**Consolidated Statements from Opponents of
the 2nd Story Project at 985 Channing Avenue, Palo Alto**

The plans were received on 08/24/20 for review by Planning Staff. Based on the initial feedback from staff, the application **cannot be deemed complete at this time**. A revised set of plans incorporating the following information and requirements must be submitted for review:

DUNLAP RESIDENCE

985 CHANNING AVENUE
PALO ALTO, CA 94301

DATE 03 AUGUST 2020

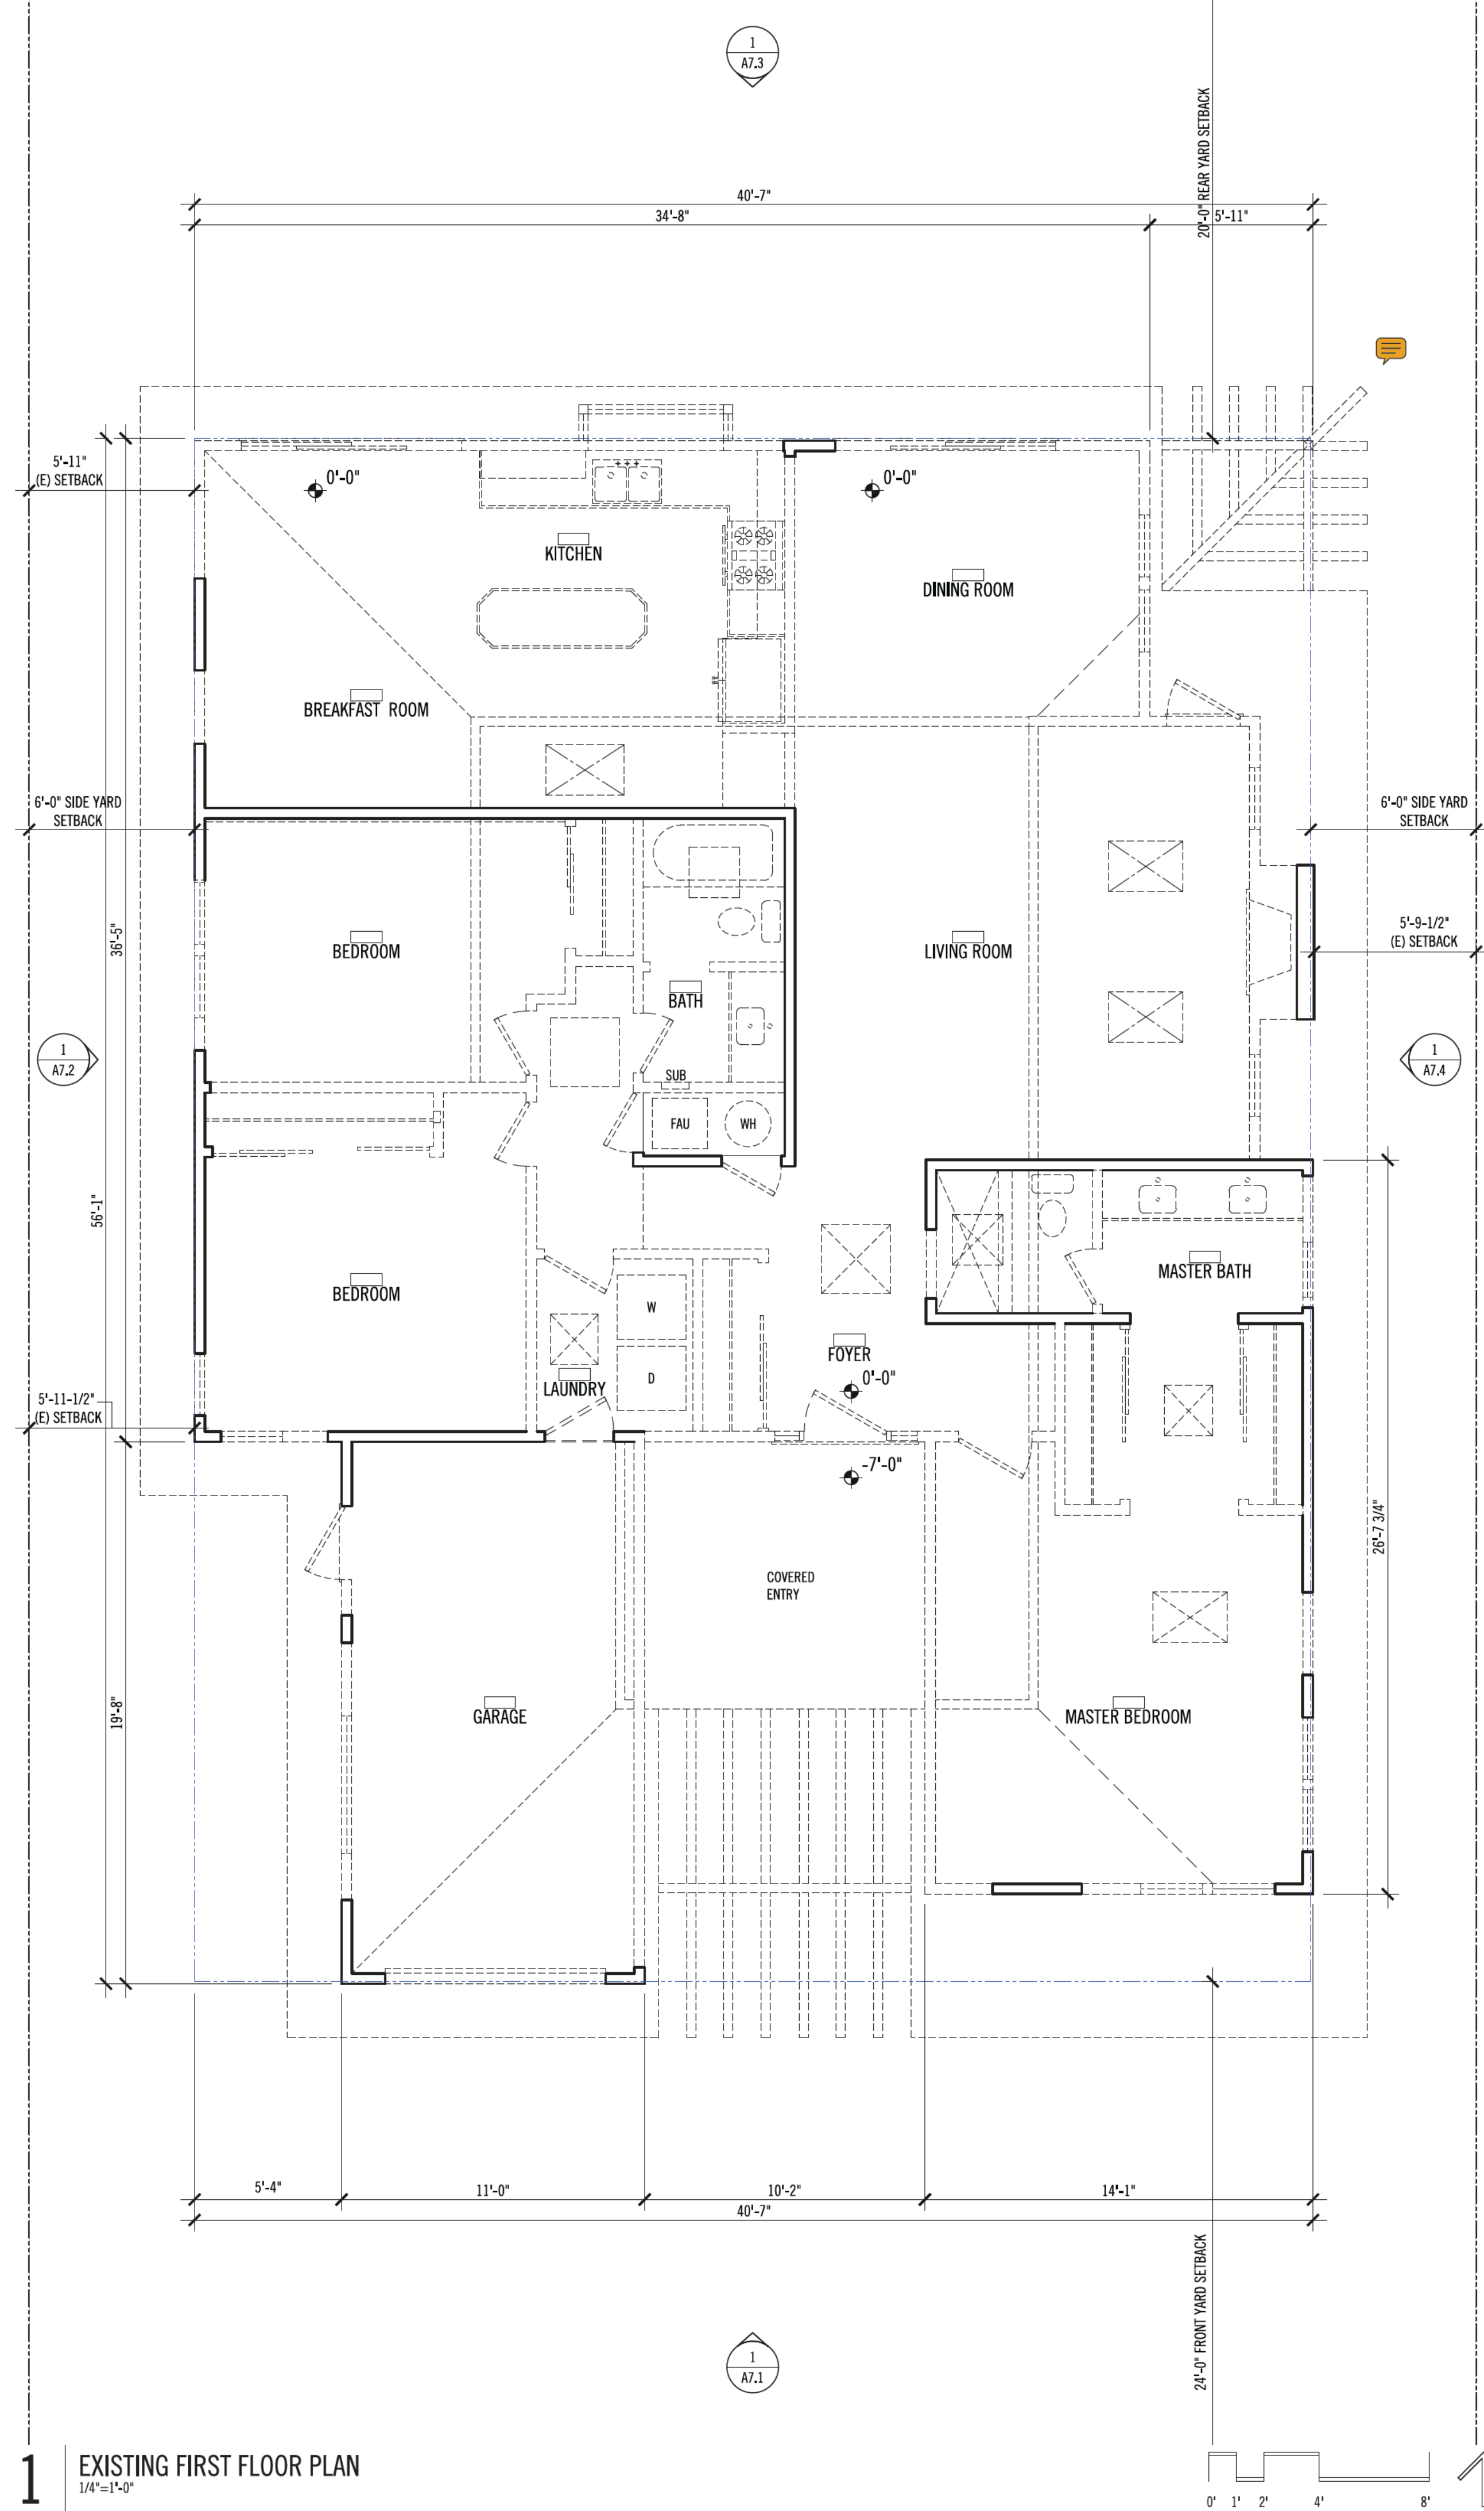
INCOMPLETE: Update plans to include mechanical equipment to be used. Provide spec sheet and decibel rating of new unit.

Any uncovered parking provided that is adjacent to a wall must provide an additional .5' of clearance space for door swing. Update the plans to provide this information.

Note driveway material

Update to show

IR-2: To meet guideline one and five, revise the site plan to provide landscape, such as medium sized screening trees or tall screening shrubs within side yards between this home and adjacent homes. Where existing landscape exists fill gaps in the landscape. Landscape can also be used to mitigate privacy, but it cannot be the primary means of privacy mitigation where direct sight lines exist to neighboring property. Provide plant choices with botanical names and quantities; indicate 24-inch box size and 8-foot minimum installed height for trees and 15-gallon size and 8-foot minimum installed height for screening shrubs.

IR-1: To meet guideline one, revise the site plan to retain the existing driveway or provide a new driveway no more than 20 feet wide with at least 2 feet planting strip along the fence line with planting. Use alternate to standard concrete and vary paving material for walkway with a design that integrates the driveway more with the landscape and yard/building entry. See guideline comments for additional discussion.

EXISTING & PROPOSED EXTERIOR ELEVATIONS - WEST

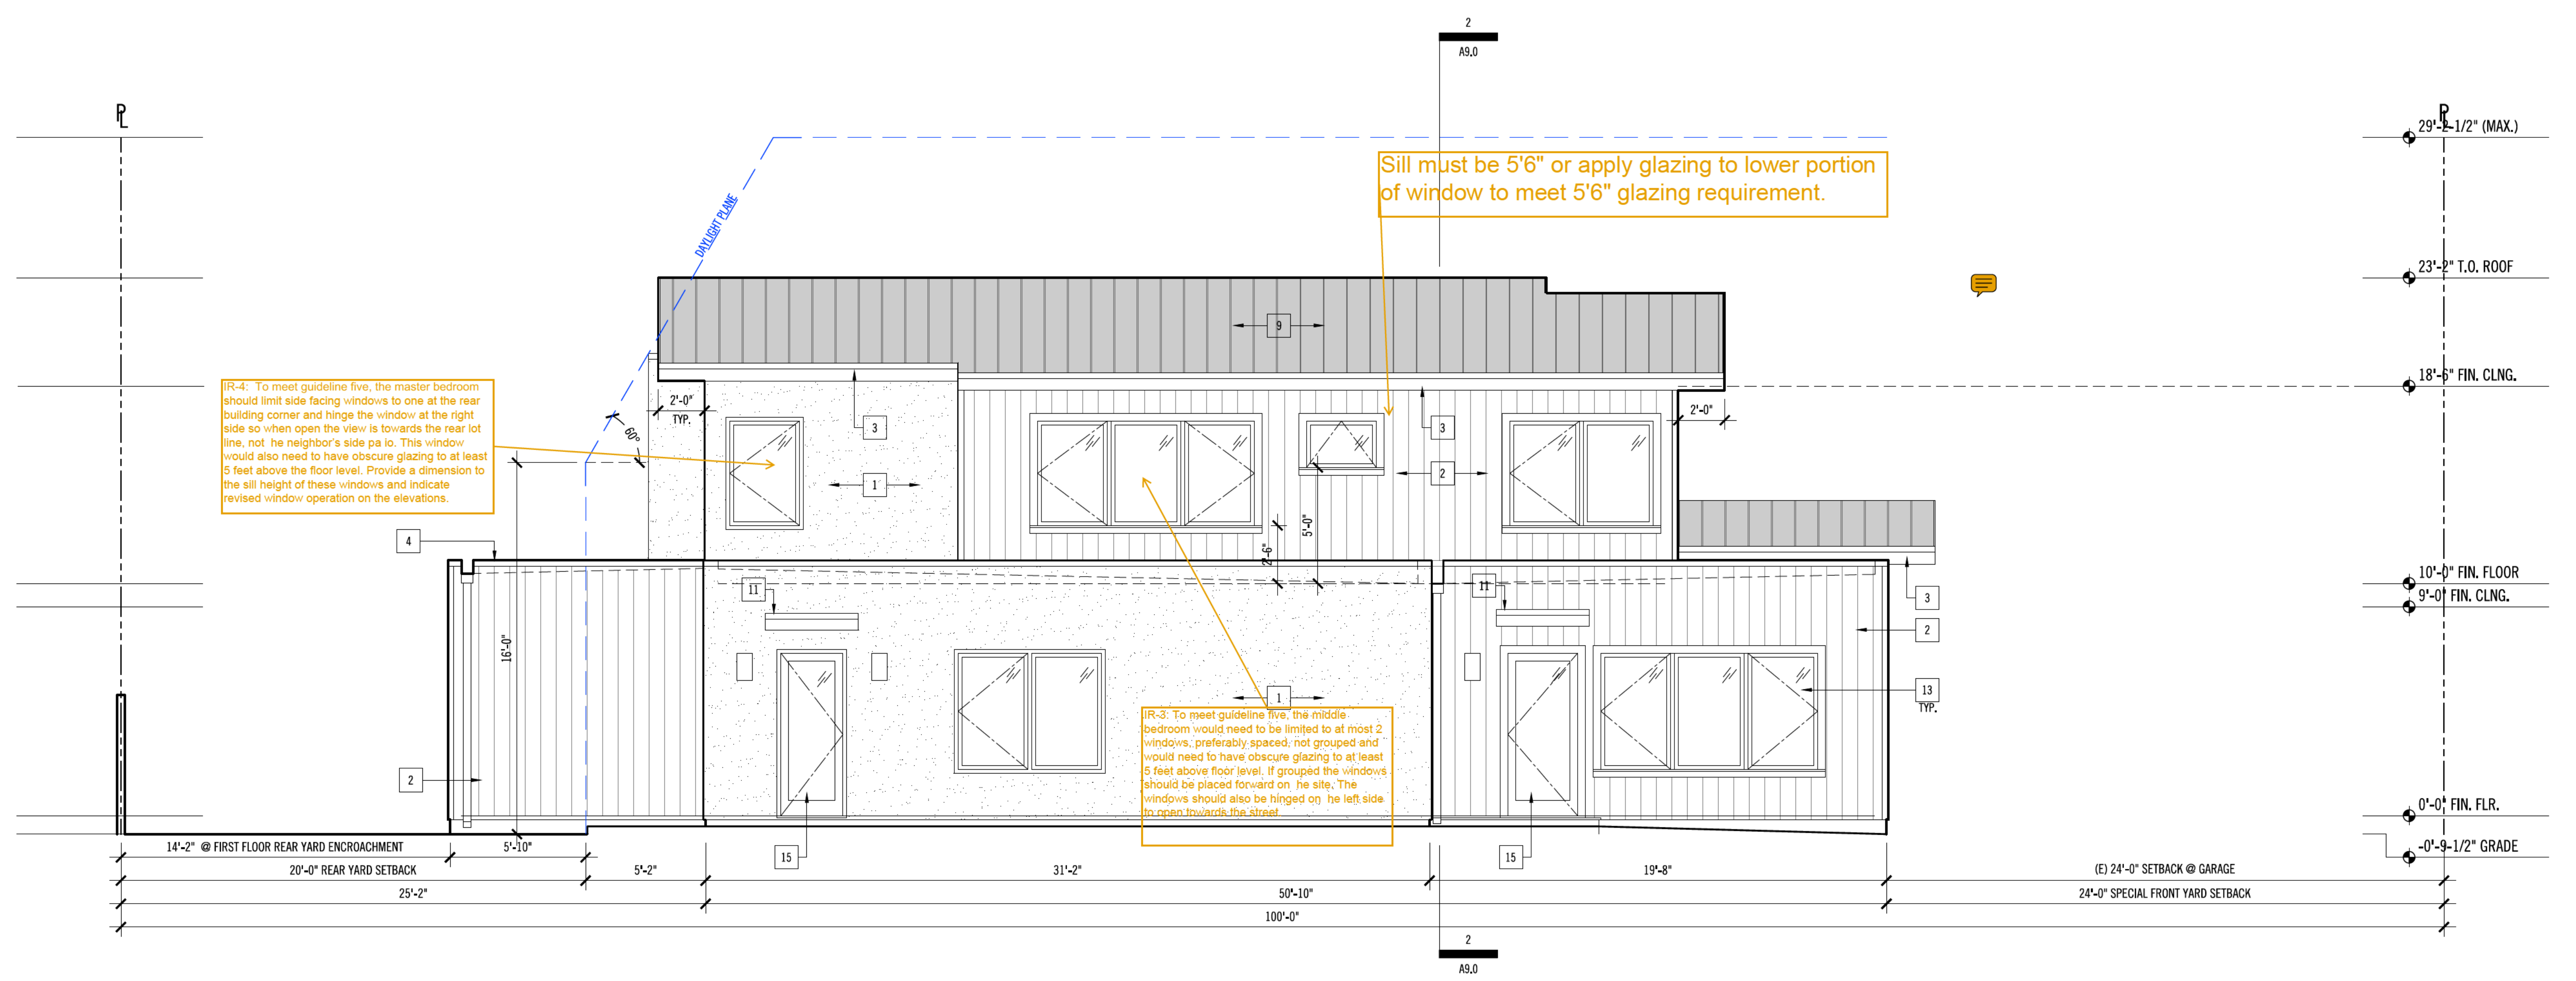
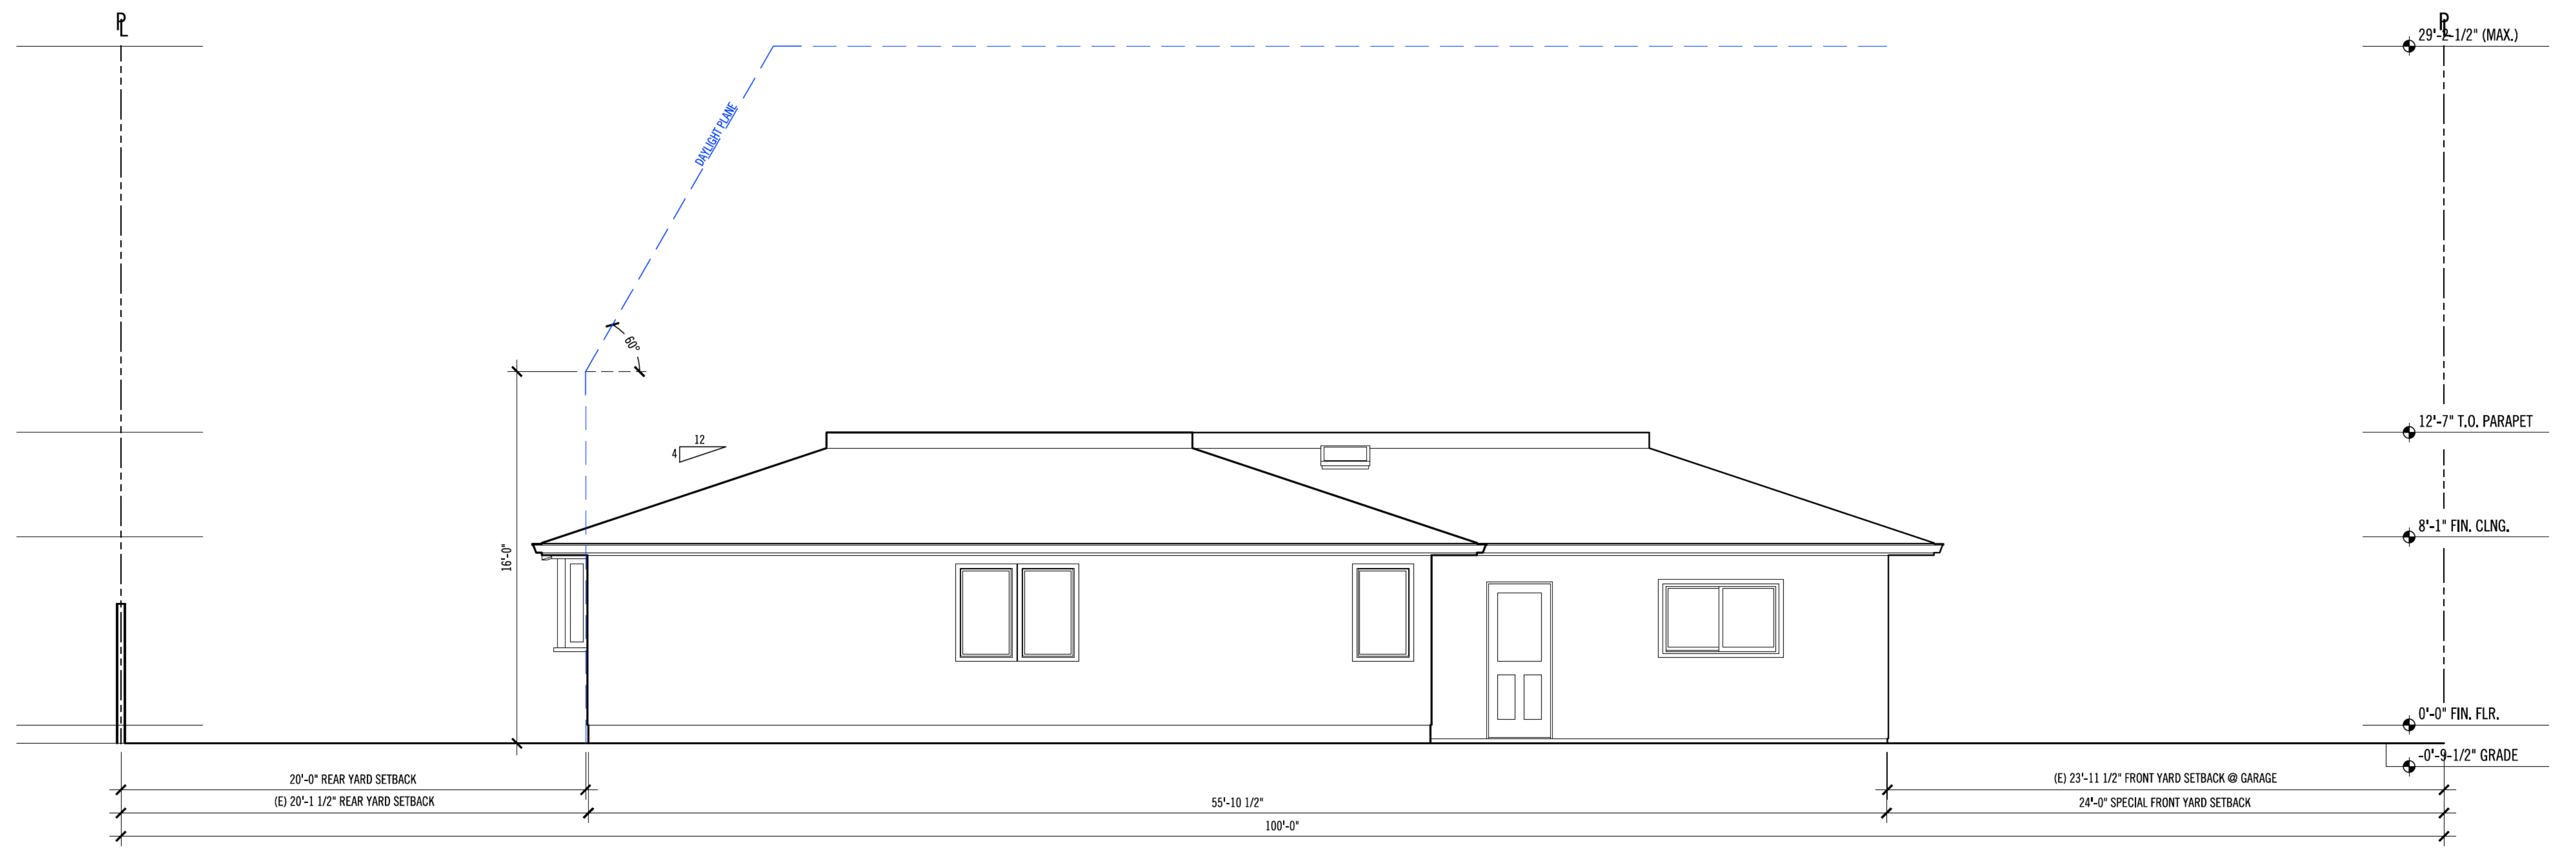
A7.2	Callout	Garrett Sauls : Planning	Sill must be 5'6" or apply glazing to lower portion of window to meet 5'6" glazing requirement.

Page Reference	Annotation Type	Reviewer : Department	Review Comments
A7.2	Comment	Garrett Sauls : Planning	Windows along this side of the building must utilize obscured glazing in order to comply with the IR Guidelines. This glazing cannot be a film applied to the window and must be applied to a minimum of 5'6" from the finished floor. Update the plans to include this information.
A8.0	Callout	Garrett Sauls : Planning	Clarify outline of drawing to identify top of roof and bottom of roof slope.
A1.0	Comment	Arnold Mammarella : Planning IR	<p>Individual Review Guidelines General Information:</p> <p>The Single-Family Individual Review process and the applicability of these guidelines were established by PAMC 18.12.110 to preserve the character of Palo Alto neighborhoods by placing specific requirements related to streetscape, massing, and privacy for new two-story homes and upper story additions.</p> <p>There are five Individual Review Guidelines: 1. Site planning for driveway, garage and house, 2. Neighborhood compatibility for height, mass, and scale, 3. Resolution of architectural form, massing, and rooflines, 4. Visual character of street facing facades and entries, and 5. Privacy from second floor windows and decks.</p> <p>For approval, a proposal needs to be consistent with all five guidelines. The review considers the proposal's response to each guideline's approval criterion statement including whether the "key points" associated with each guideline have been followed. Guideline illustrations are also used to inform determinations in the evaluation. Please see the City's illustrated guideline booklet for more information about these regulations.</p> <p>Individual Review Evaluation Comments:</p> <p>Review determinations and comments relate to plans filed August 31, 2020 for a whole house renovation with a new second story addition to an existing one-story house. The existing attached garage would be converted to space within a new attached ADU.</p> <p>Review comments may reference specific changes or clarifications needed to meet the guidelines, including those shown on specific plan sheets. No neighbor comments were available at the time of this review. Note: Evaluation for zoning compliance is provided separately.</p> <p>G1 — Site Planning: Placement of Driveway, Garage, and House</p> <p>Approval Criterion: The driveway, garage, and house shall be placed and configured to reinforce the neighborhood's existing site patterns (i.e. Building footprint, configuration and location, setbacks, and yard areas) and the garage and driveway shall be subordinate to the house, landscaping and pedestrian entry as seen from the street.</p> <p>[Guideline Key Points: 1. Minimize the driveway's presence and paving; 2. Locate the garage to be subordinate to the house; 3. Configure the house footprint to fit the neighborhood pattern; 4. Create landscaped open spaces between homes; 5. Locate the upper floor back from the front facade and/or away from side lot lines when next to one-story homes; and 6. Do not place the second floor so that it emphasizes the garage.]</p> <p>Comments: The property is a 52.5' wide by 99.6' deep interior lot on the north side of Channing Avenue one lot in from Lincoln Avenue. It abuts a similarly sized corner lot 991 Channing Avenue with a tall one-story house on its right (east) side, 975 Channing Avenue, a narrow deep interior lot with a stepped mass and fairly low two-story</p>

Page Reference	Annotation Type	Reviewer : Department	Review Comments
A7.2	Callout	Arnold Mammarella : Planning IR	IR-3: To meet guideline five, the middle bedroom would need to be limited to at most 2 windows, preferably spaced, not grouped and would need to have obscure glazing to at least 5 feet above floor level. If grouped the windows should be placed forward on the site. The windows should also be hinged on the left side to open towards the street.
A7.2	Callout	Arnold Mammarella : Planning IR	IR-4: To meet guideline five, the master bedroom should limit side facing windows to one at the rear building corner and hinge the window at the right side so when open the view is towards the rear lot line, not the neighbor's side patio. This window would also need to have obscure glazing to at least 5 feet above the floor level. Provide a dimension to the sill height of these windows and indicate revised window operation on the elevations.
